E4990A-02

S E R V I C E N O T E

E4990A – Impedance Analyzer

E4990A Chassis Assembly and Rear Panel replacement part number change.

**Figure 1-1 New Rear panel and Chassis assembly**

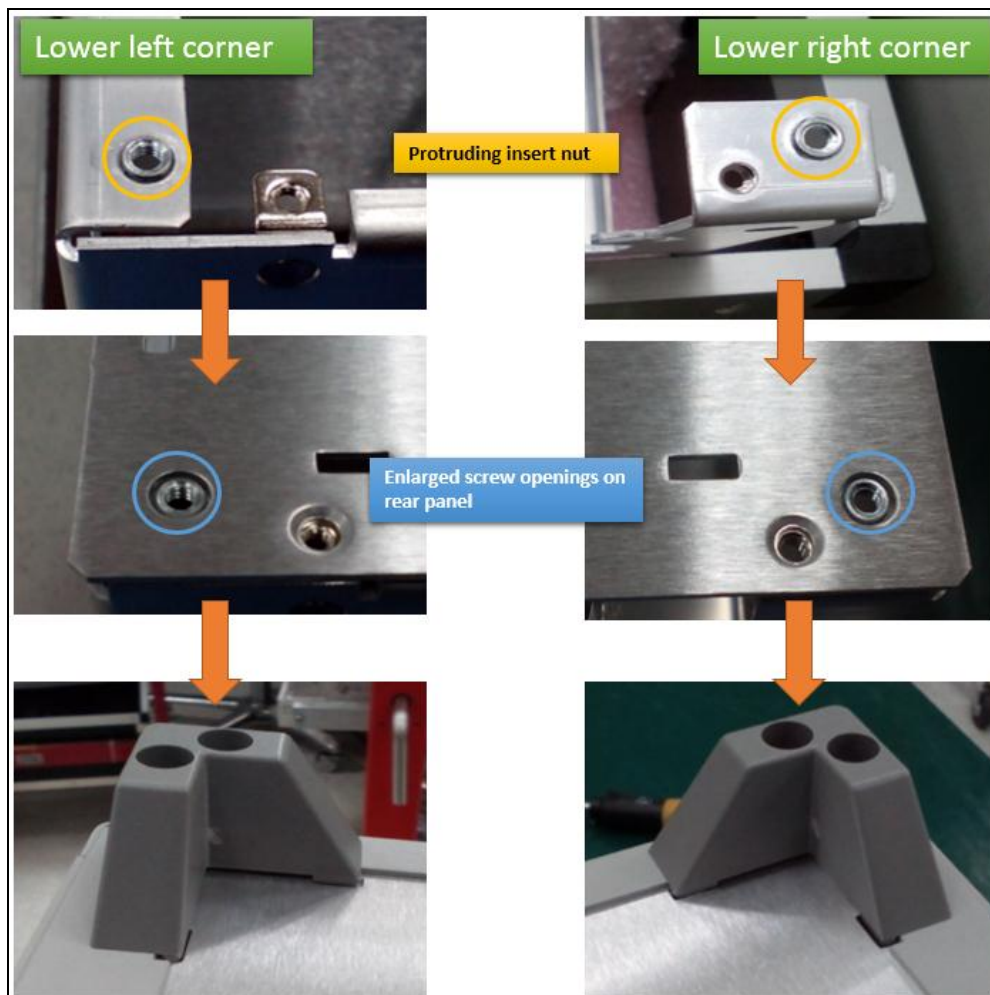
New and improved rear panel and chassis assembly is introduced. Due to mechanical (dimension) change, both rear panel and chassis assembly are required to be replaced with “new” part number on hardware compatibility when either one of the “old” part number is depleted.

The new and improved rear panel and chassis assembly would to further improve the grip between the rear panel and chassis assembly. The insert nut of the chassis assembly is made to be slightly protruded (~1.2mm) resulting in the direct contact (same surface) when the rear panel (~1.2mm in thickness) is installed.

Replace **both** rear panel and chassis assembly whenever one of the following old part is required to be replaced. Shown in Table 1-1 is the replacement part support plan for E4990A. Refer to Figure 1-1 for the detailed illustration on the changes.

Perform full calibration in ensuring the instrument is well within specification since the chassis assembly replacement would require the removal and assembly of analog modules.
